# Appendix Q

## US Coast Guard Navigation Report

# TECHNICAL MEMORANDUM: NAVIGATION REPORT

**Subject:** RE: FHWA South Carolina: Navigation Study; US 278 Corridor, Beaufort County  
**Date:** Thursday, November 21, 2019 1:26:59 PM  
**Attachments:** [US 278 Navigation Report Final October 2019.pdf](#)

PLAN OF  
 CLEARANCES  
 FOR BRIDGE  
 OVER  
 MACKEY CREEK

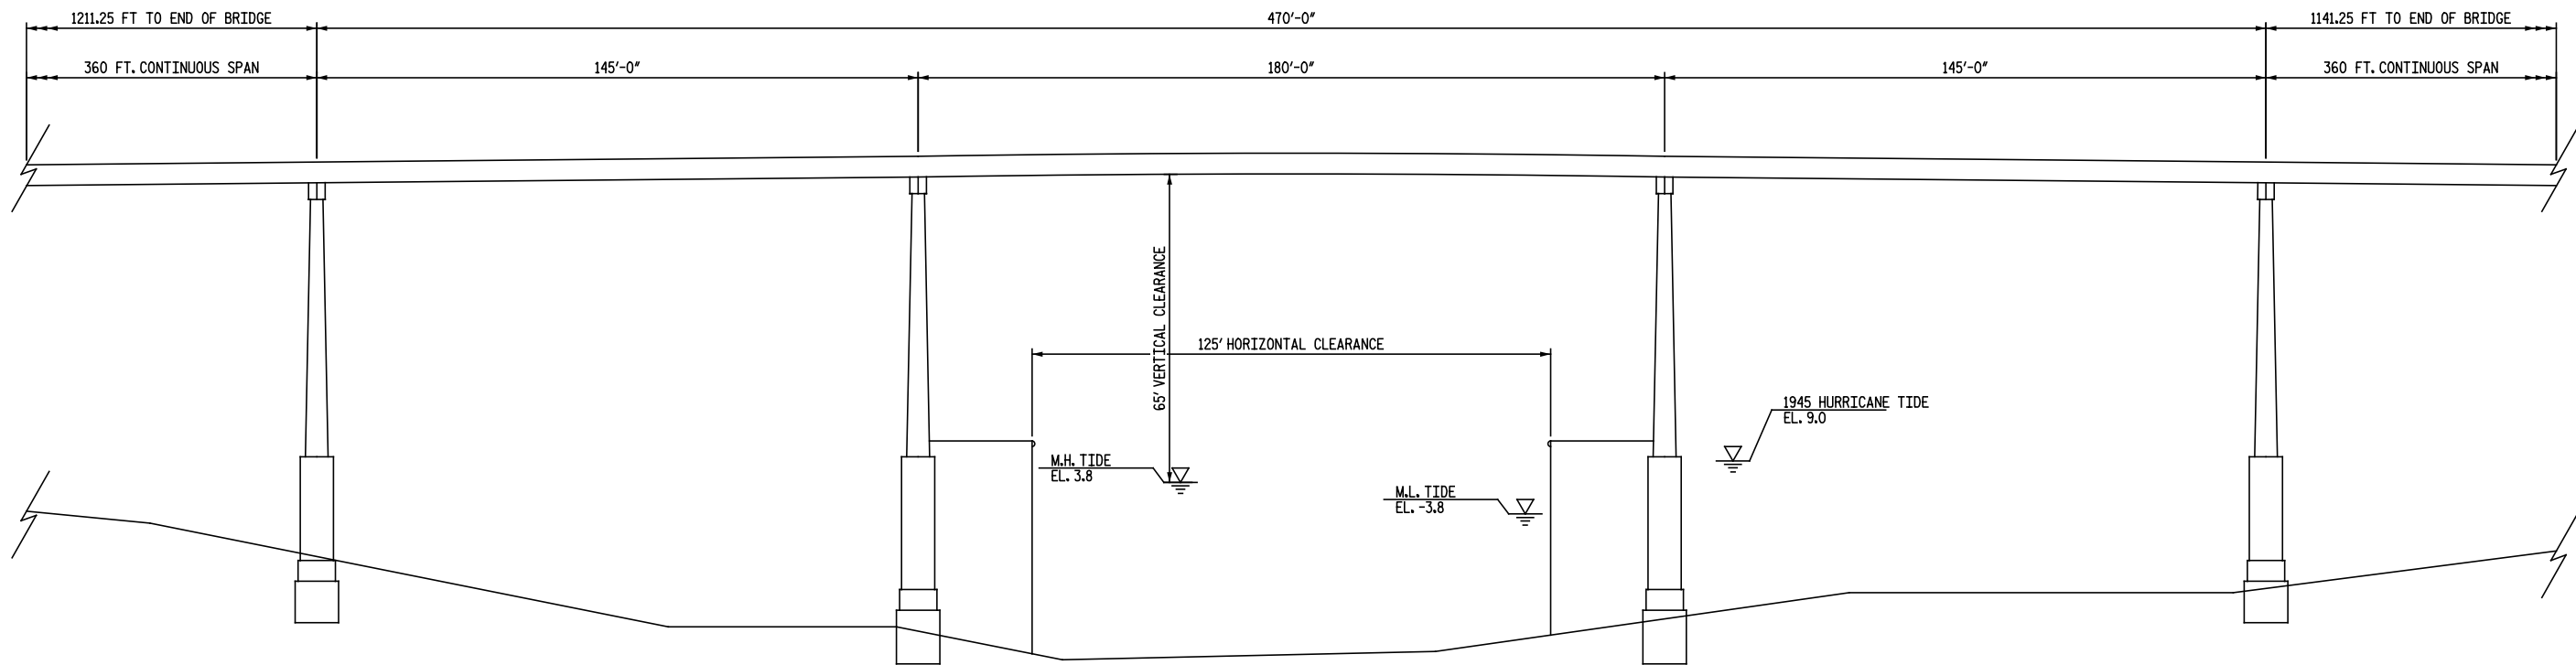
1. Mackay Creek – Proposed minimum horizontal clearance 60 ft. Proposed minimum vertical clearance 25 ft. above Mean High Water (MHW)
2. Skull Creek (AICW) - Proposed minimum horizontal clearance 125 ft. Proposed minimum vertical clearance 65 ft. above Mean High Water (MHW)

The Coast Guard has made a preliminary determination that the proposed clearance, as stated above, will meet the reasonable needs of navigation for these waterways. Please note that this preliminary determination does not constitute an approval or final agency action. The Coast Guard can only make a final determination after processing a complete bridge permit application.
